UNITED STATES PATENT AND TRADEMARK OFFICE

APPLICATION NO.	FILING DATE	FIRST NAMED INVENTOR	ATTORNEY DOCKET NO.	CONFIRMATION NO.
09/418,083	10/14/1999	ANTHONY NARISI	TN099	8378

Office Action Summary	Application No.	Applicant(s)	
	09/418,083	NARISI ET AL.	
	Examiner	Art Unit	
	Andrew Caldwell	2151

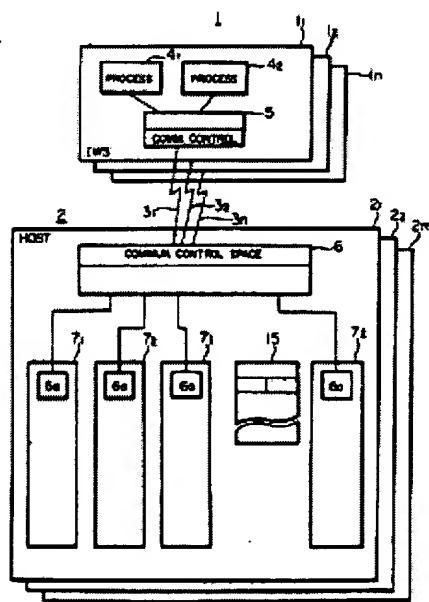
The drawings are objected to under 37 CFR 1.83(a). The drawings must show feature of the invention specified in the claims. Therefore, the following must be or the feature(s) canceled from the claim(s): the subject matter of the last 7 lines claim 1 and the corresponding subject matter in method claim 15. No new matter be entered.

9 As to the objection to the drawings, the Applicants' argument, that the feature is
10 somehow too complicated to be displayed, has been fully considered but is not deemed
11 persuasive. Assuming without conceding that the Applicants' invention is embodied in
12 Figure 6. Figure 6 could be modified like the one shown below to include multiple
13 cascaded NT Servers in a manner similar to elements 2₁ to 2_m.

A proposed drawing correction or corrected drawings are required in reply to the action to avoid abandonment of the application. The objection to the drawings
will be held in abeyance.
